Access Compliance Report

Public Rights-of-Way

(Pedestrian Signals)

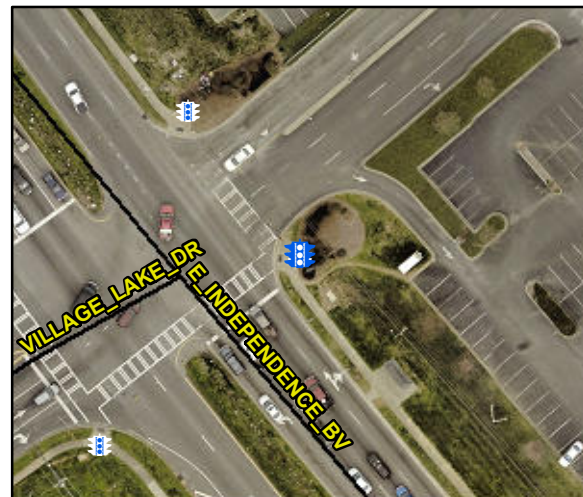
Intersection ID: N/A	Main Street:	Cross Street: N/A	Location: N/A
ADA ID: 65D3A53A5F40	Signal Type: Two Push Buttons-Non APS	Overall Compliance: No	Severity Score: BTN 1:N/A BTN 2: N/A No BTN: N/A
Codes/Mitigation Info/Possible Solution		Field Measurements/Component Compliance

PROW/ADA: TMUTCD 4e.08, R404.2, R404.3, R406.2

Possible Solutions: Replace Signal Push Button With APS Button on New Post. Remove & Relocate Sign.
